## HISTORIC PRESERVATION BOARD STAFF REPORT

### Upton Park - 103 NW 5th Avenue

Meeting	File No.	Application Type
May 7, 2025	2024-164	Level 2 Site Plan Modification, Certificate of Appropriateness, & Waiver

ROOFTOP LANDSCAPE CALC. (LDR Section 4.3.3(RR)(3))	
TOTAL ROOFTOP AREA	2,721 SF. (100%)
MIN. REQ'D. LANDSCAPE	272 SF. (10.0%)
PROVIDED PLANTER L'SCAPE	276 SF. (10.14%)

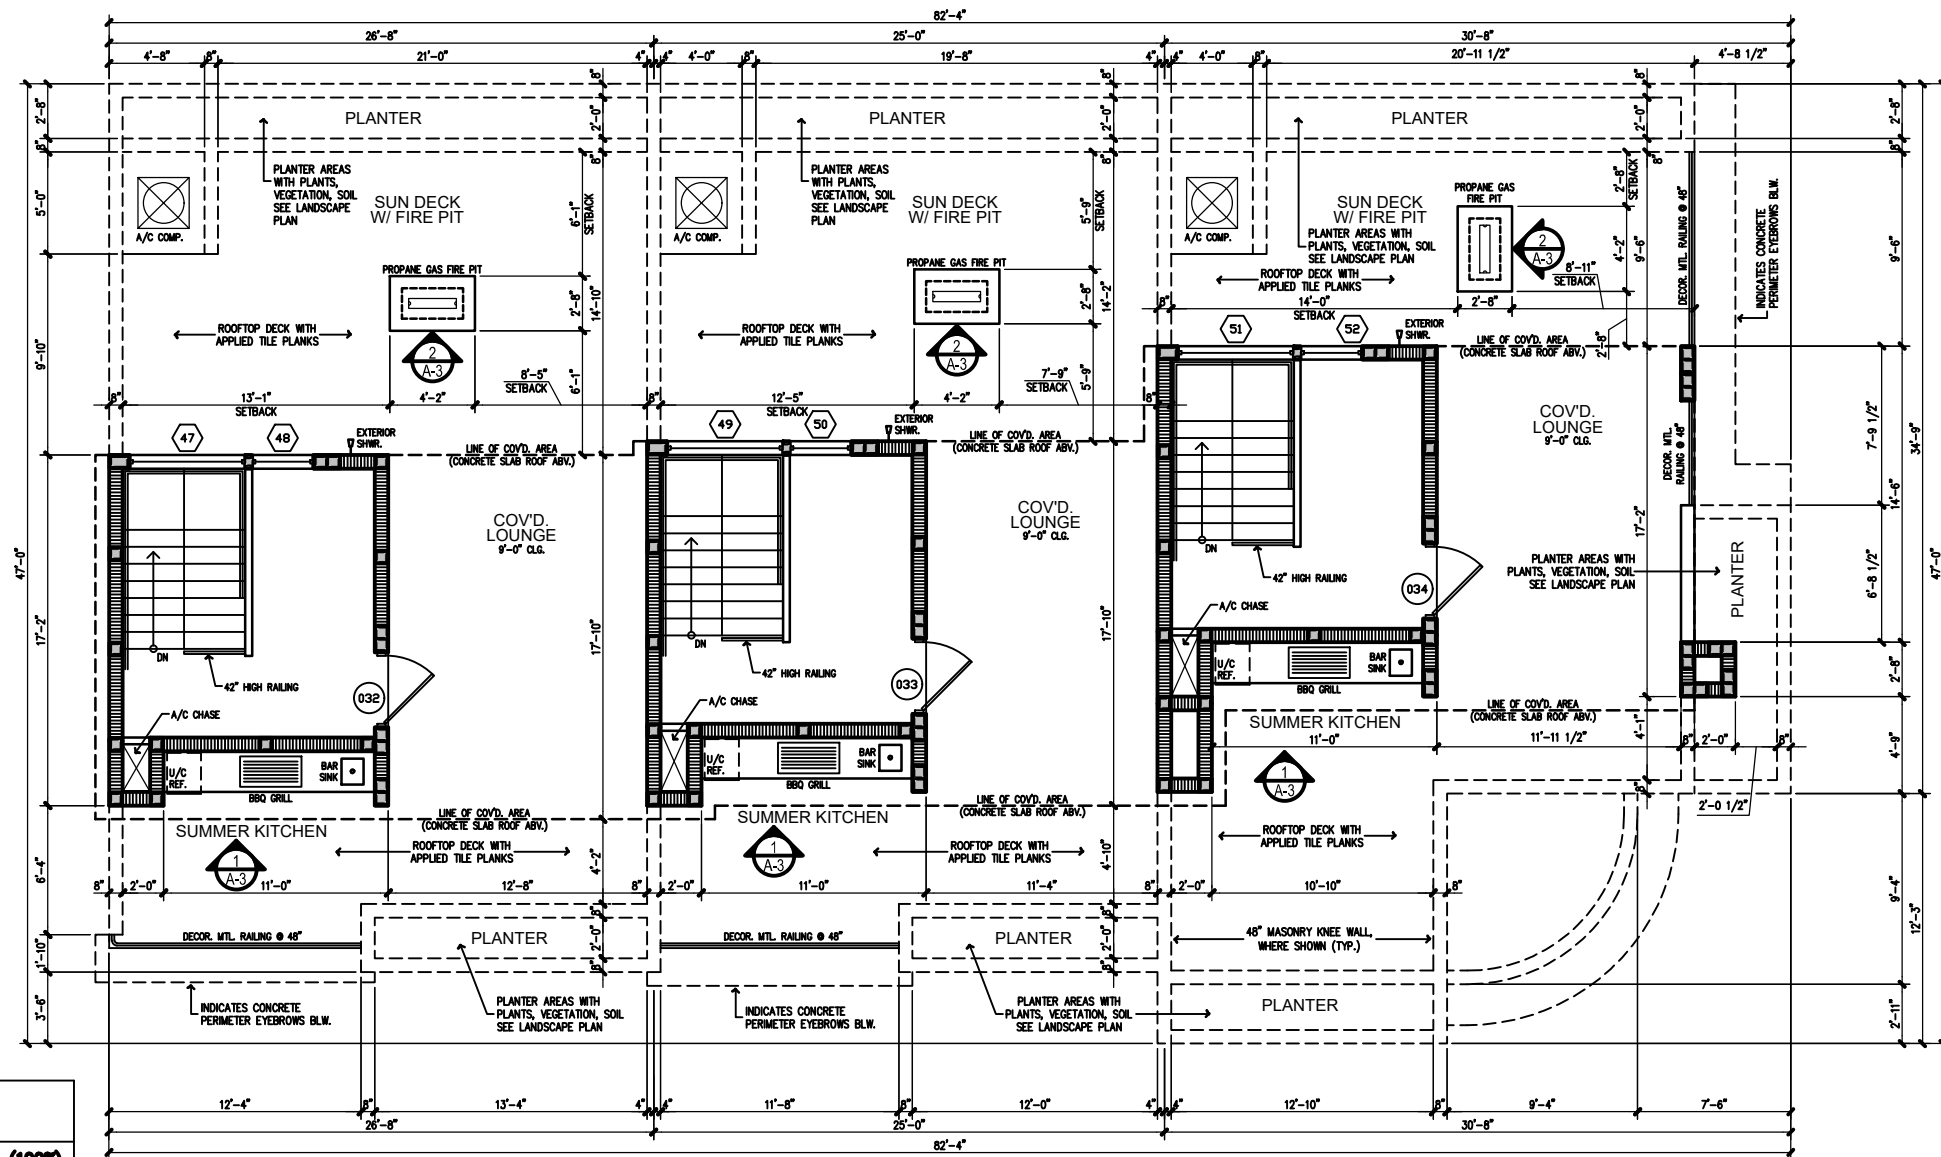
The subject request includes a rooftop terrace that contains covered areas and landscaping which meets the minimum requirements at 10.14% (276 sq. ft.). However, the applicant has not specified how the rooftop materials will meet this requirement, this is included as a site plan technical item.

6. That the applicant include documentation to show compliance with the standards to reduce urban heat islands for both roofed and non-roofed areas of development within the CBD.

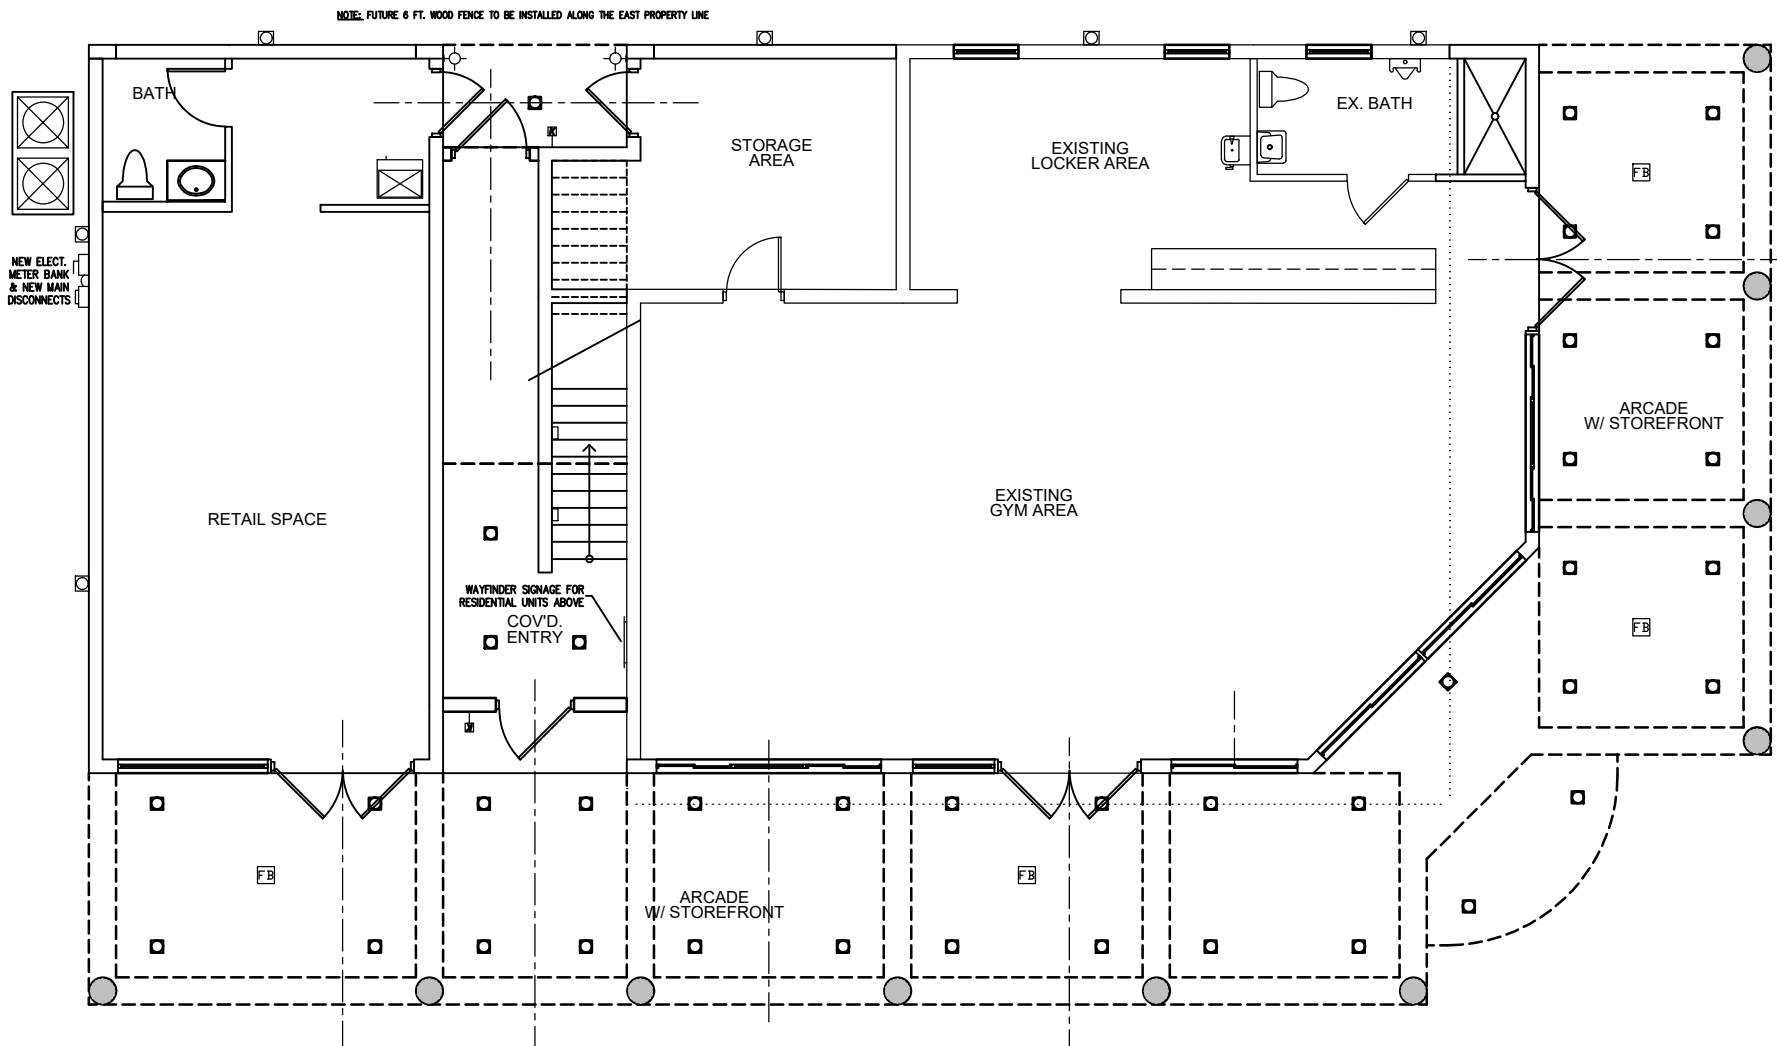
A Photometric Plan has been submitted; however, it does not comply with the Lighting regulations. The photometric plan is required to show existing and proposed illumination for the storefront on the west side of the building fronting NW 5<sup>th</sup> Avenue, as well as show a maximum spillage of .25 on the south side of the property line fronting NW 1<sup>st</sup> Street. This has been added as a site plan technical item.

9. Include all proposed fencing on the site plan.
10. Revise photometric plan to ensure it meets the Lighting requirements of LDR Section 4.6.8.
11. That the park impact fee of \$500.00 per dwelling unit will be collected prior to issuance of a building permit.
